V2500-A1/A5 SERIES PROPULSION SYSTEMS NON-MODIFICATION SERVICE BULLETIN

This document transmits Revision 2 to Non-Modification Service Bulletin
V2500-NAC-71-0308

NON-MODIFICATION SERVICE BULLETIN – NACELLE – FAN COWL – INSPECTION FOR FAN COWL
DISBOND (FOR CONTROLLED SERVICE USE)

Left Hand Door
Figure 1

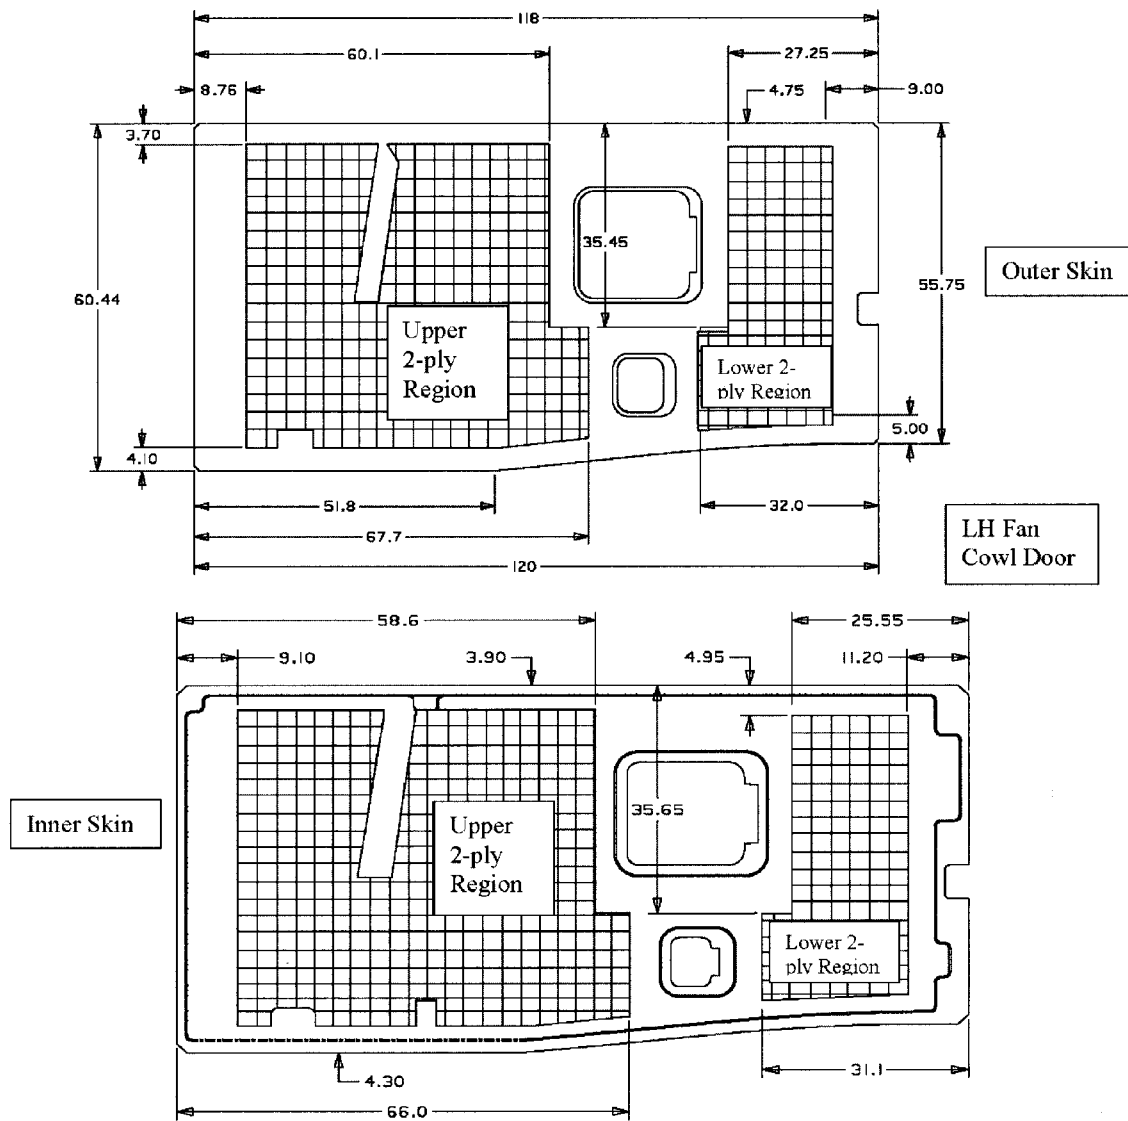
- (1) Conduct a general visual inspection of the fan cowl (Refer to the AMM 05-24-30-200-003).
- (2) Conduct a tap test on the fan cowl door (Refer to the NTM 51-10-03 for tap test instructions and Figure 1 and Figure 2 for inspection areas).
- (3) If a disbond is discovered, determine the affected area
 - (a) If a disbonded area in the upper region is less than or equal to 576 sq. in. (3716 sq. cm) or in the lower region less than or equal to 186 sq in. (1200 sq cm), refer to step 3.A.(3)(b)(i) and (ii). If the disbonded area is greater than the limit or there is disbond in both the upper and the lower region, skip to 3.A.(3)(b)(iii). Refer to Figures 1 and 2 for area definition.
 - (b) Any disbond must be within the main panel body as indicated in Figures 1 and 2.

- (iii) If the disbond is greater than the limits posted in Step (3)(a) above, but less than 1000 sq. in. (6452 sq. cm) in the upper 2-ply region and/or 400 sq. in. (2581 sq. cm) in the lower 2-ply region, complete the form in Appendix 1 and submit the appropriate figure with an approximation of the disbond area drawn directly onto the figure to Goodrich. See step 3.A.(4) for contact information.

(v) A disbond greater than the indicated limit and less than or equal to 1680 sq. in. (10838 sq. cm) in the upper 2-ply region and/or less than or equal to 544 sq. in. (3510 sq. cm) in the lower 2-ply region requires a One Time Concession (OTC) request from the Goodrich Repair group to enable fly-on. Duration of fly-on and interval of inspection will be assessed on a case-by-case basis. Complete a Nacelle Damage Description (NDD) form and submit the document to your regional Goodrich Airline Support Manager (ASM). For any damage strictly above 1680 sq. in. (10838 sq. cm) in the upper region and/or 544 sq. in. (3510 sq. cm) in the lower region, the part must be removed and repaired.
